DESCRIPTION OF DIFFERENCES

between CURRENT MODEL and NEW MODEL

CURRENT MODEL	NEW MODEL
Name of Appliance :	Center Module	Center Module
Model No. :	WX-CC411	WX-CC411A
FCC ID :	ACJ9TAWX-CC411	ACJ9TAWX-CC411A
IC ID :	216A-WXCC411	216A-WXCC411A

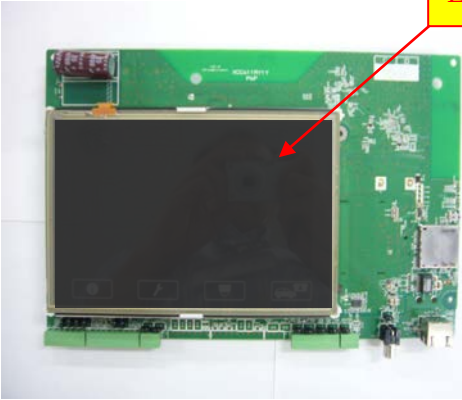
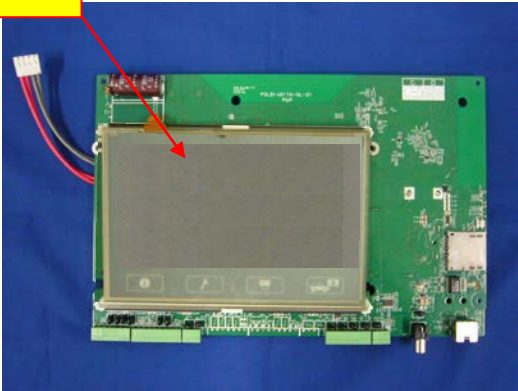
CURRENT MODEL WX-CC411	NEW MODEL WX-CC411A
LCD Display	Manufacturer: LG Display Co., Ltd. Type: LB070WV4 LCD Type: TFT 	Manufacturer: Shanghai Tianma Micro-Electronics Co. Ltd. Type: TM070RDHG20 DCLK frequency: 30MHz 
LCD Display Diver/ RF Unit/ Antenna
